UNITED STATES ENVIRONMENTAL PROTECTION AGENCY
WASHINGTON, D.C. 20460

The U.S. Environmental Protection Agency is currently conducting a completeness review of the U.S. Department of Energy's (DOE) 2014 Compliance Recertification Application (CRA-2014) for the Waste Isolation Pilot Plant (WIPP). The Agency first needs to determine whether the CRA-2014 is complete before it undertakes a full technical evaluation of the recertification. Based on our initial review, we have determined that the CRA-2014 is not yet complete, and this letter transmits the first set of completeness questions and comments that the Agency has for DOE (see Enclosure).

FIRST SET OF EPA COMPLETENESS COMMENTS FOR CRA 2014

MARCH 17, 2014
 WASTE ISOLATION PILOT PLANT
 CARLSBAD, NEW MEXICO
 PHASE 2B UNDERGROUND MAP

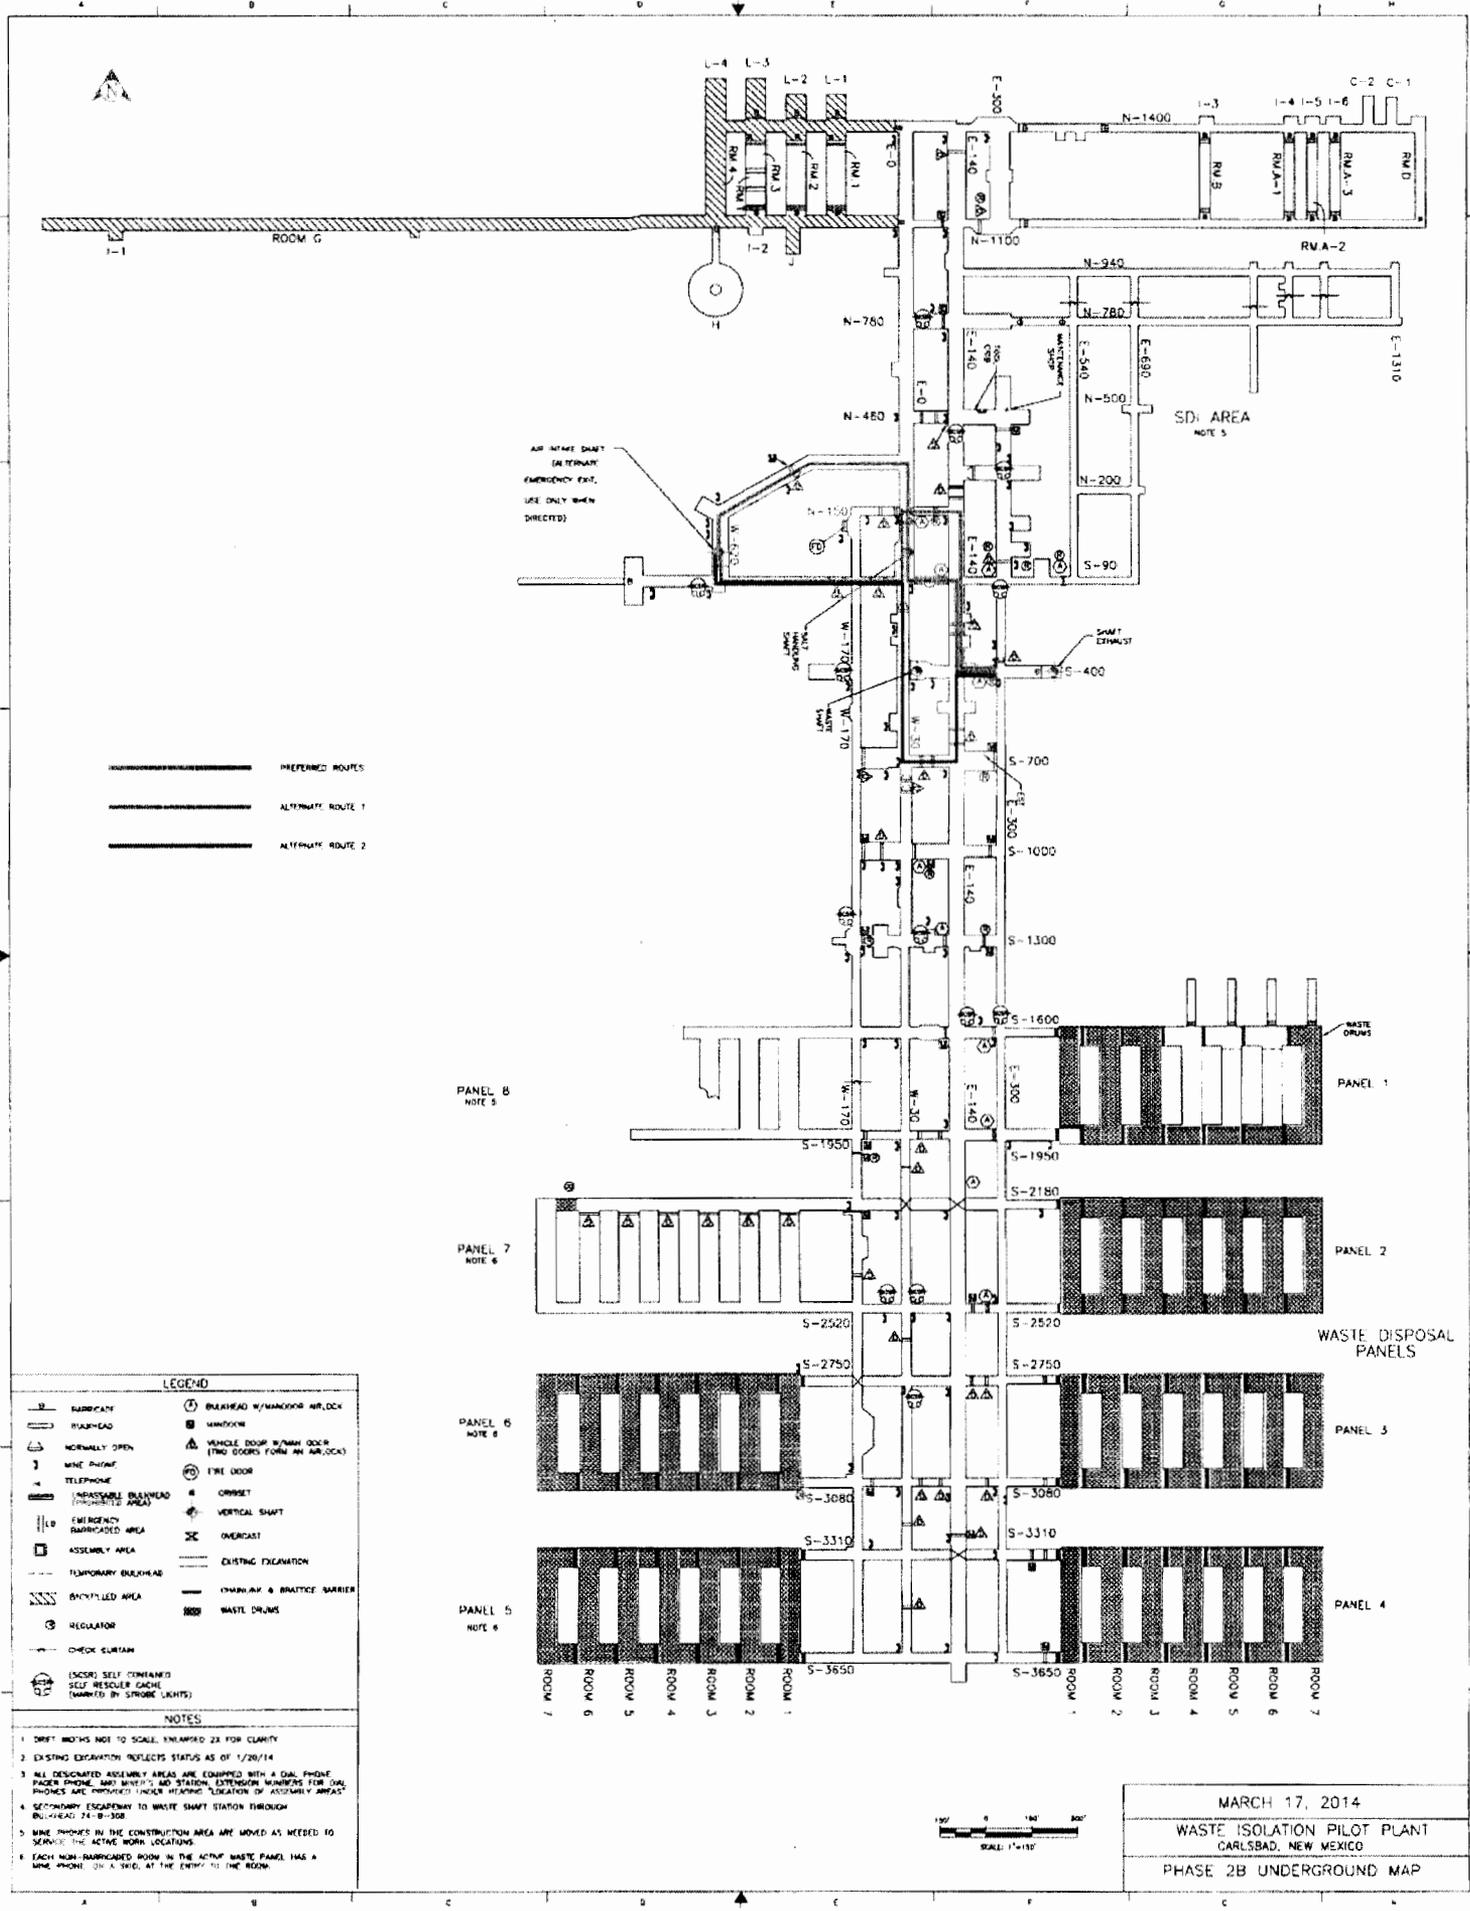
1. Explain how DOE arrived at a volume of 148,011 m³ for the underground.
2. In the diagram of repository ventilation during recovery (see attached, labeled *Phase 2B Underground Map*, dated March/17/2014) a large portion of the north experimental area is denoted as 'backfilled'. Please provide information of the material properties of these backfilled areas and how they are modeled during the 10,000 year regulatory period in the CRA-2014 PA.
